June 27, 2013

Contract No. T200800901.01  
Federal Aid Project No. ESTP-S999(88)  
HSIP SUSSEX COUNTY - US 9 PROJECTS  
Sussex County

Enclosed is Addendum No. 1 for the referenced contract consisting of the following:

<b>CONSTRUCTION PLAN</b>	SHEET NO.
	28
	TOTAL SHTS.
	161

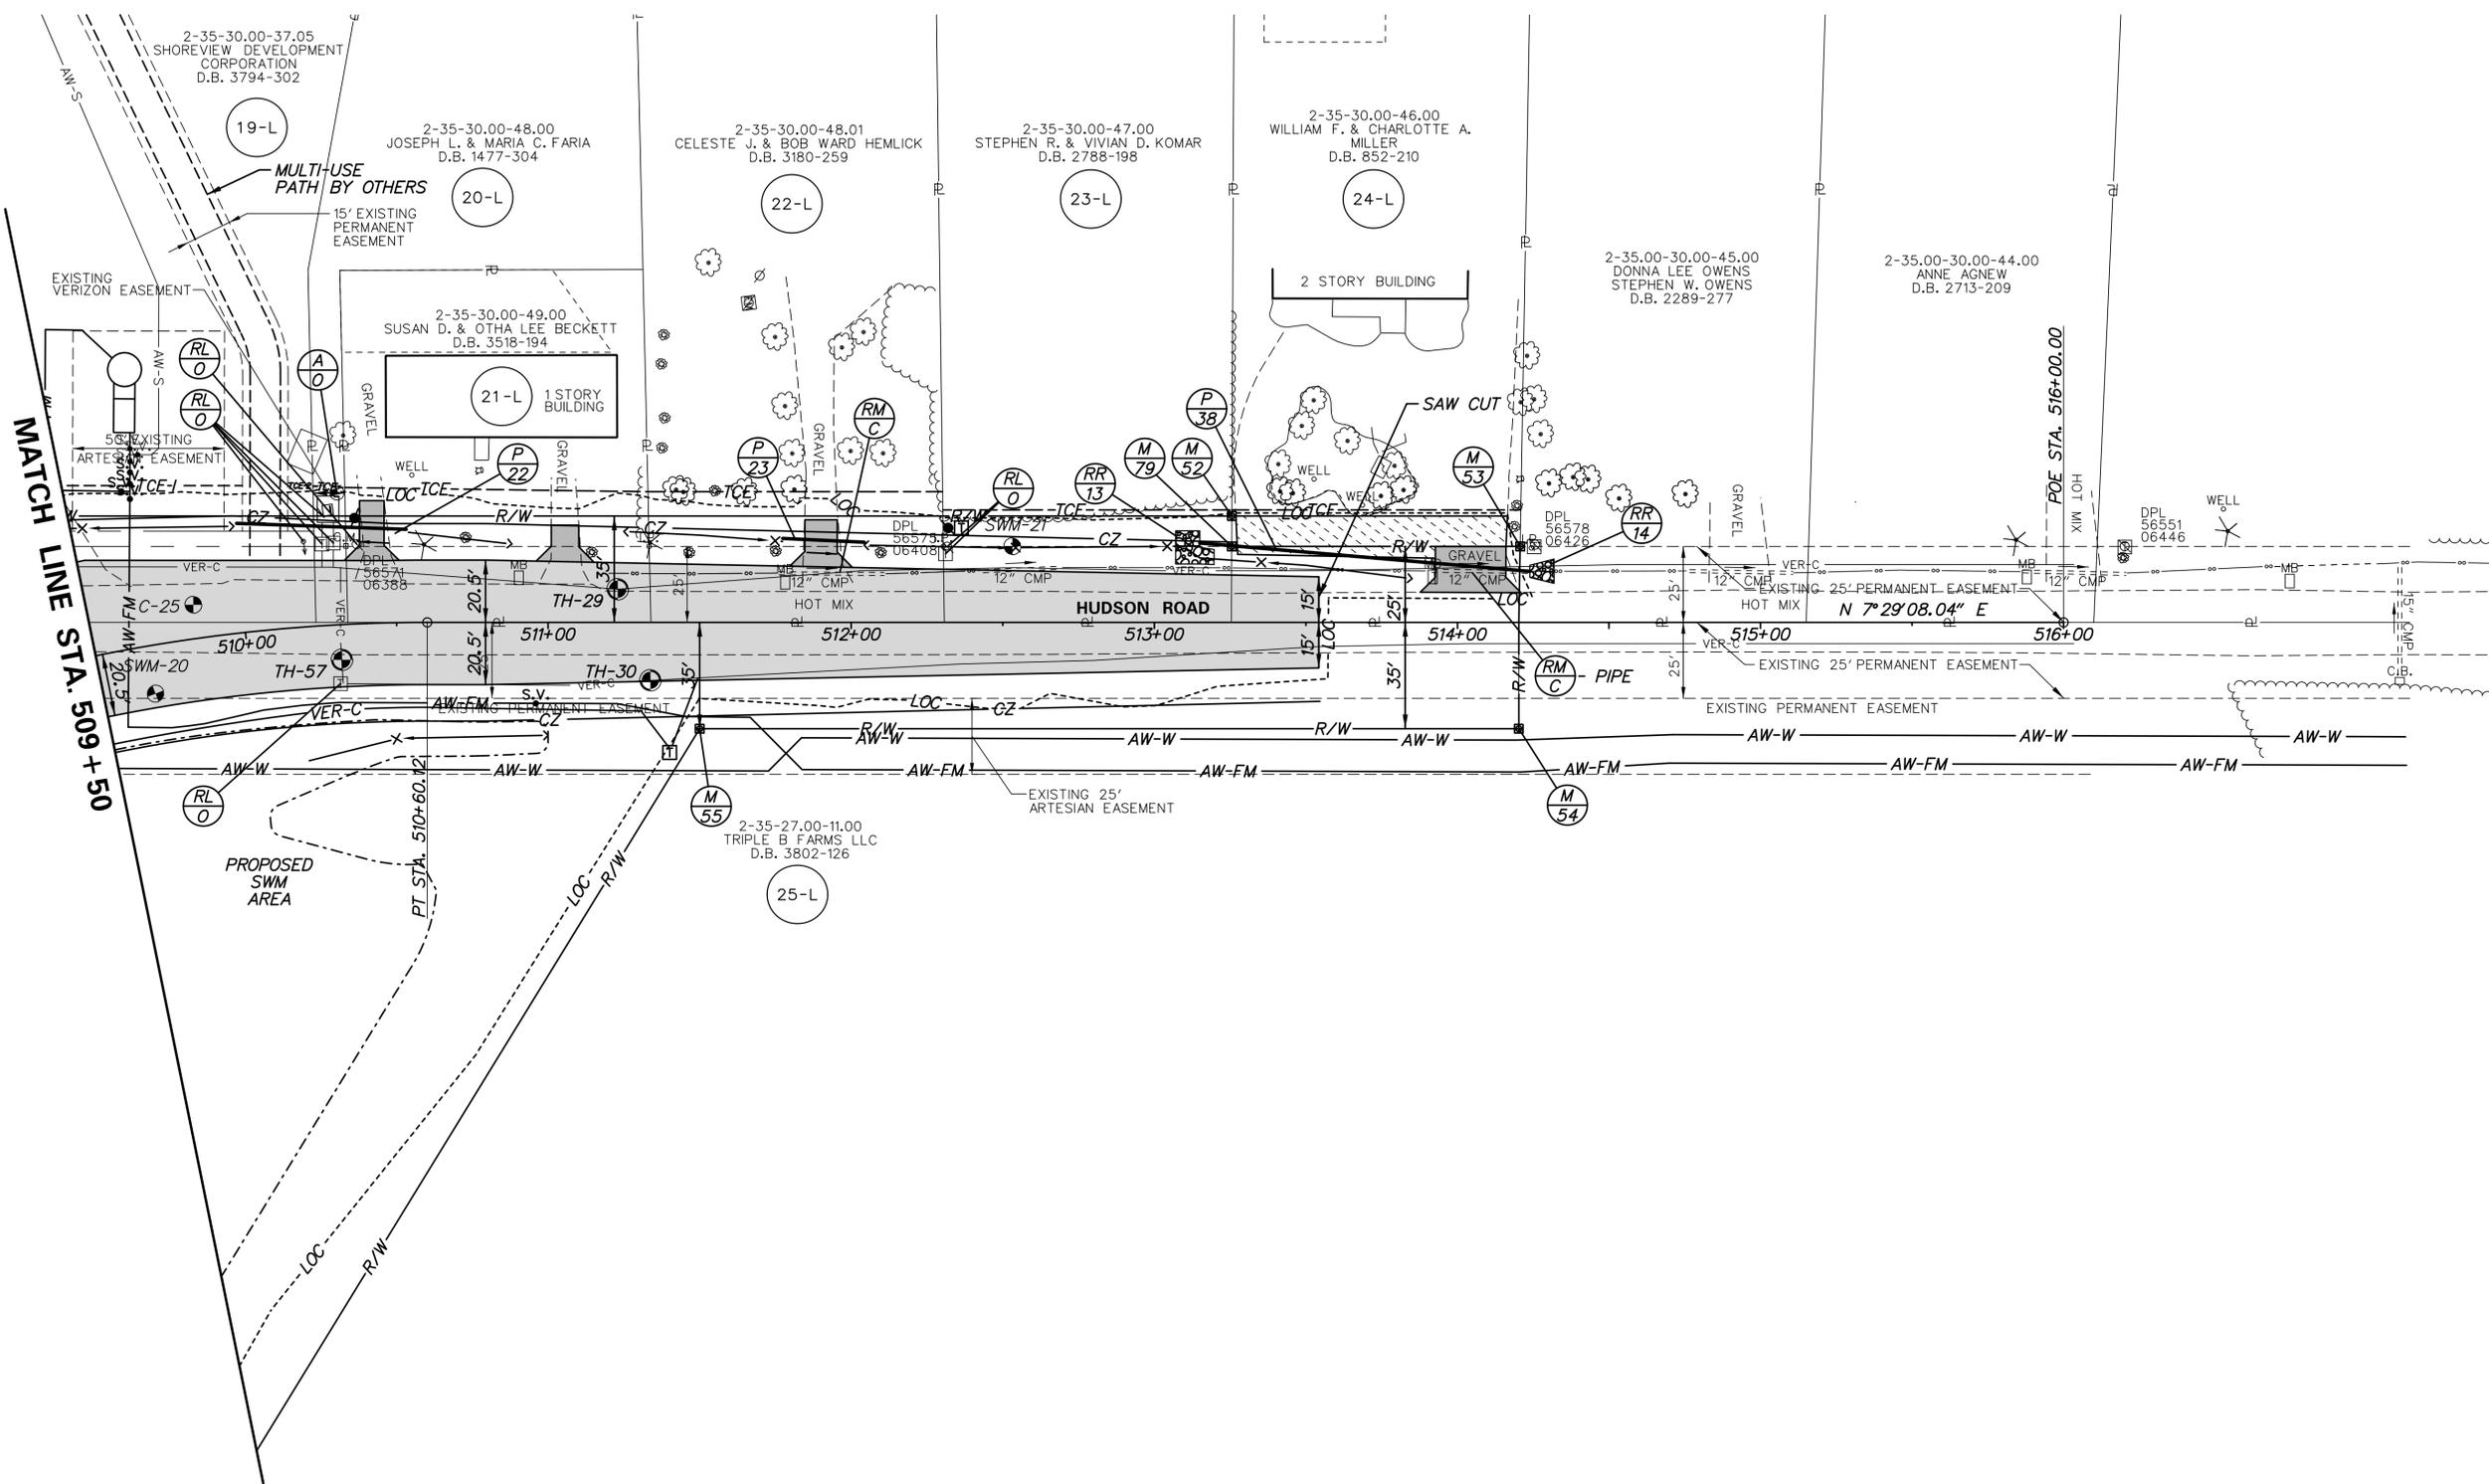
ADDENDUMS / REVISIONS	
△	REVISED CLASS ON P-38; R/RW/GS 06/25/13
